RE: Revised Site Plan Review for the new Wolter INC at 1768 W Matthew DR
(Parcel WD-364-D-505-8)

Thank you for the revised site plan for the new Wolter INC at 1768 W Matthew DR. The City of De Pere staff reviewed the site plan on October 24, 2023, and recommended approval with the following nine conditions that need to be addressed prior to obtaining occupancy permits:

2 MONUMENT SIGN
SCALE: 1/2" = 1'-0"

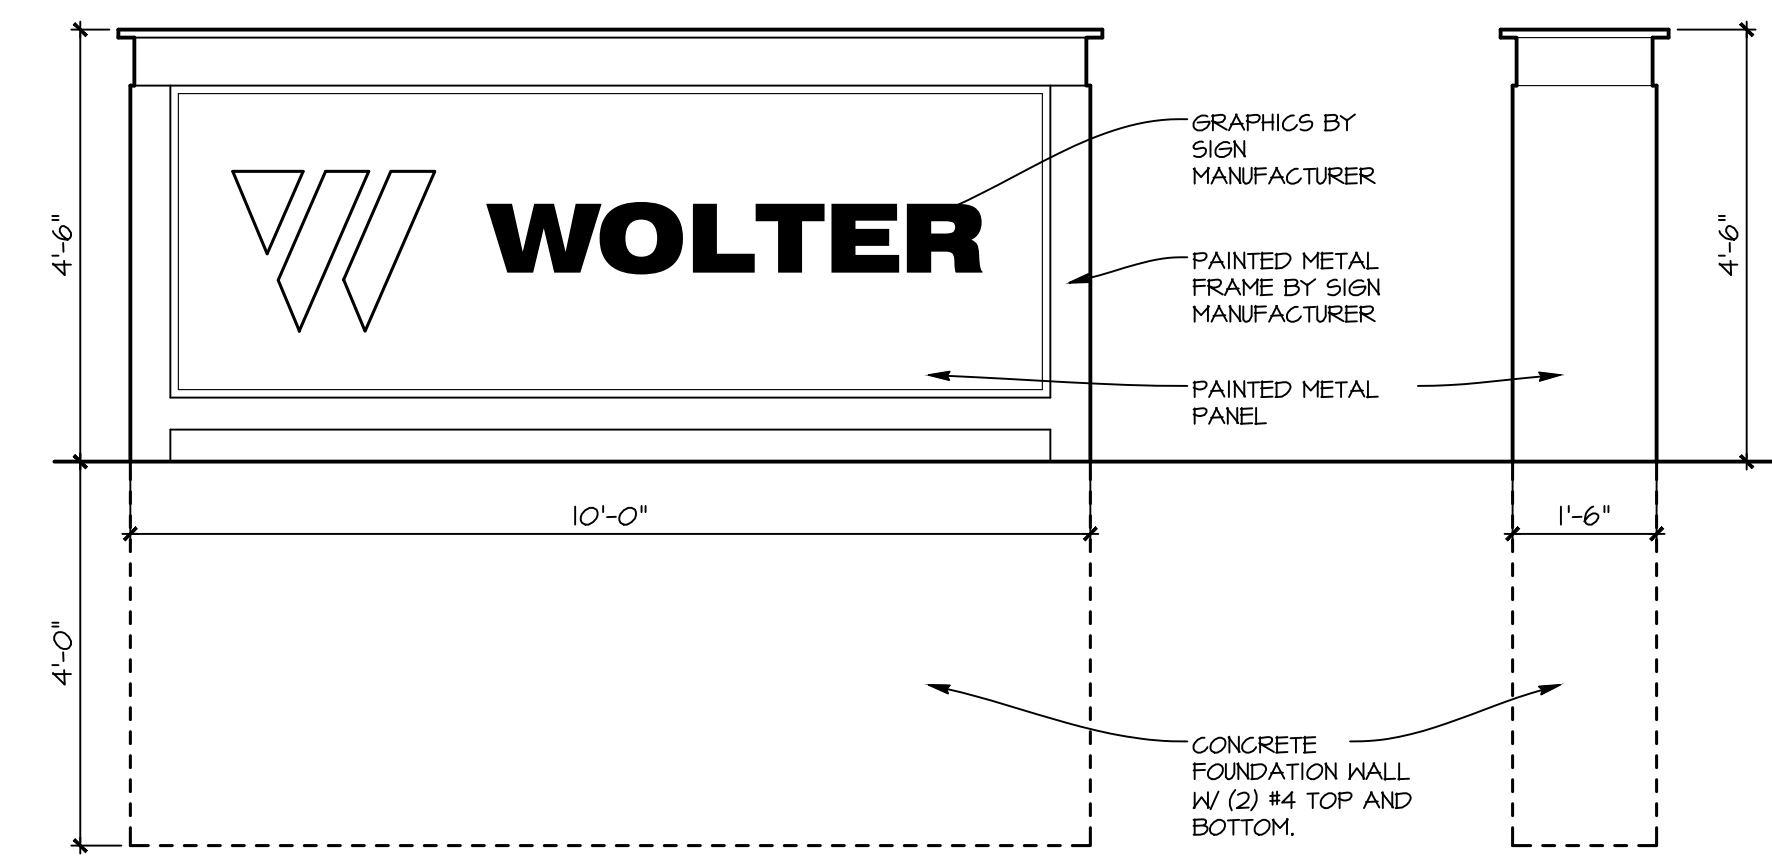
- Sheet A0.1: The monument sign base must have a base that is at least 18" in height The base must be free of sign copy . The sign must incorporate design details, materials, and colors of the associated building.
